# Access Compliance Report

## Public Rights-of-Way

### (Curb Ramps)

Intersection ID: 48771	Main Street: LUMBER_LN	Cross Street: TURNING_WHEEL_DR	Location: NE
ADA ID: 29AC4B82A5CA	Ramp Type: Perp	Initial Pass/Fail: Fail	Overall Compliance: No
Severity Score: 8.75			
Codes/Mitigation Info/Possible Solution		Field Measurements/Component Compliance

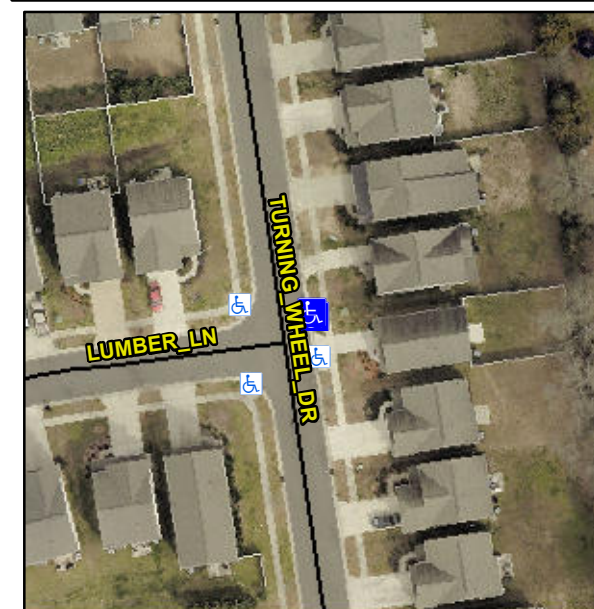
**Not Found, R304.5.1**

Compliance	Description	Data	Compliance	Description	Data
N/A	Ramp Length (in)	71.0	Yes	Ramp Slope (%)	7.7
No	Ramp Width (in)	47.0	Yes	Ramp XSlope (%)	1.3
N/A	Flare Type LT	N/A	N/A	Flare Type RT	N/A
N/A	Flare Slope LT (%)	N/A	N/A	Flare Slope RT (%)	N/A
N/A	Flare Traversable LT?	N/A	N/A	Flare Traversable RT?	N/A
N/A	Landing Length (in)	N/A	N/A	DWS Provided?	N/A
N/A	Landing Width (in)	N/A	N/A	DWS Contrast?	N/A
N/A	Landing Slope (%)	N/A	N/A	DWS Length (in)	N/A
N/A	Landing X Slope (%)	N/A	N/A	DWS Full Width?	N/A
N/A	Landing Curb? (Y/N)	N/A	N/A	DWS Offset (in)	N/A
N/A	Shared Landing?	N/A			
N/A	Gutter Ponding?	N/A	N/A	Gutter Slope (%)	N/A
N/A	Gutter Lip Ht (in)	N/A	N/A	Gutter X Slope (%)	N/A
N/A	Painted X Walk1?	No	N/A	Painted X Walk2?	N/A
	X Walk 1 Direction	To W		X Walk 2 Direction	N/A
N/A	X Walk 1 Width (in)	N/A	N/A	X Walk 2 Width (in)	N/A
	X Walk 1 Slope (%)	4.3		X Walk 2 Slope (%)	N/A
	X Walk 1 X Slope (%)	1.8		X Walk 2 X Slope (%)	N/A

**Remove & Replace Entire Ramp.**
